DLL state diagram mappings v101

Info (not part of baseline)

Figure 145–13 — Top level PSE state diagram

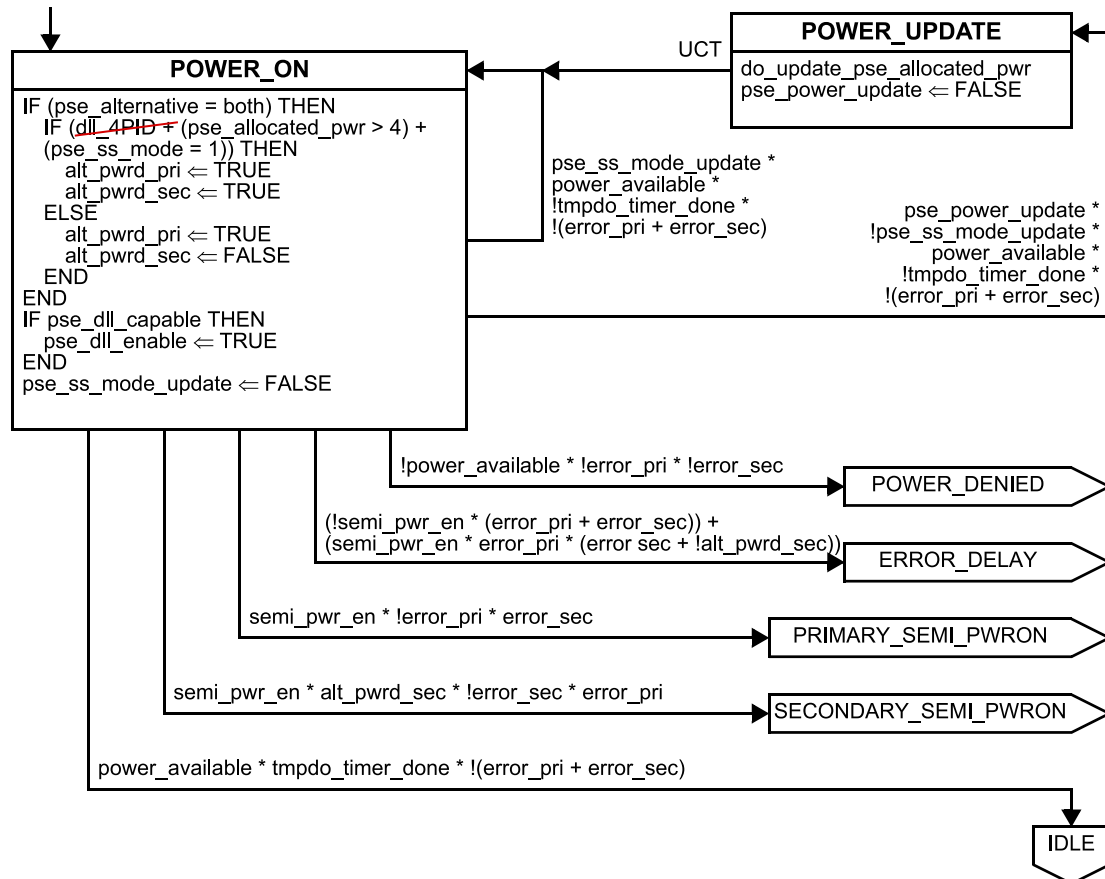
A somewhat related issue is that the variable `dll_4PID`, when set, forces a 4-pair capable PSE to provide 4-pair. The intent of `dll_4PID` was to provide extra information, it should not actually mandate any particular behavior. Note that this variable is removed from the PSE side of things only. On the PD side it remains in use in the state diagram, as Type 3 and Type 4 PDs are required to set this bit.

Remove variable `dll_4PID`.

Change Figure 145–13 (page 142) as follows:
